Access Compliance Report

Public Rights-of-Way

(Curb Ramps)

Intersection ID: 44731	Main Street: BENFIELD_RD	Cross Street: PROSPERITY_PARK_DR	Location:	N
ADA ID: 2024F44BA64D	Ramp Type: PerpDiag	Initial Pass/Fail: Fail	Overall Compliance: No	Severity Score: 25
Codes/Mitigation Info/Possible Solution		Field Measurements/Component Compliance

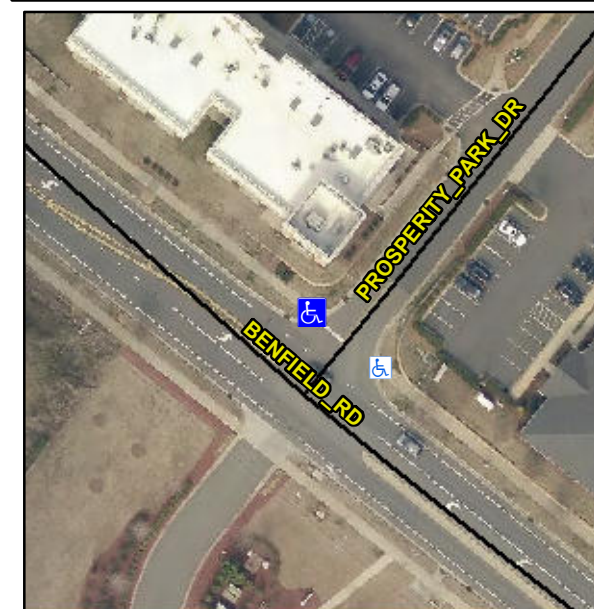
R304.2.2

Compliance	Description	Data	Compliance	Description	Data
N/A	Ramp Length (in)	71.0	No	Ramp Slope (%)	20.0
Yes	Ramp Width (in)	49.0	Yes	Ramp XSlope (%)	0.0
N/A	Flare Type LT	N/A	N/A	Flare Type RT	N/A
N/A	Flare Slope LT (%)	N/A	N/A	Flare Slope RT (%)	N/A
N/A	Flare Traversable LT?	N/A	N/A	Flare Traversable RT?	N/A
N/A	Landing Length (in)	N/A	N/A	DWS Provided?	N/A
N/A	Landing Width (in)	N/A	N/A	DWS Contrast?	N/A
N/A	Landing Slope (%)	N/A	N/A	DWS Length (in)	N/A
N/A	Landing X Slope (%)	N/A	N/A	DWS Full Width?	N/A
N/A	Landing Curb? (Y/N)	N/A	N/A	DWS Offset (in)	N/A
N/A	Shared Landing?	N/A			
N/A	Gutter Ponding?	N/A	N/A	Gutter Slope (%)	N/A
N/A	Gutter Lip Ht (in)	N/A	N/A	Gutter X Slope (%)	N/A
N/A	Painted X Walk1?	No	N/A	Painted X Walk2?	No
	X Walk 1 Direction	To SW		X Walk 2 Direction	To SE
N/A	X Walk 1 Width (in)	N/A	N/A	X Walk 2 Width (in)	N/A
	X Walk 1 Slope (%)	0.9		X Walk 2 Slope (%)	2.3
	X Walk 1 X Slope (%)	1.6		X Walk 2 X Slope (%)	2.1

Remove & Replace Curb Ramp With Two New Directional Ramps or Equivalent.
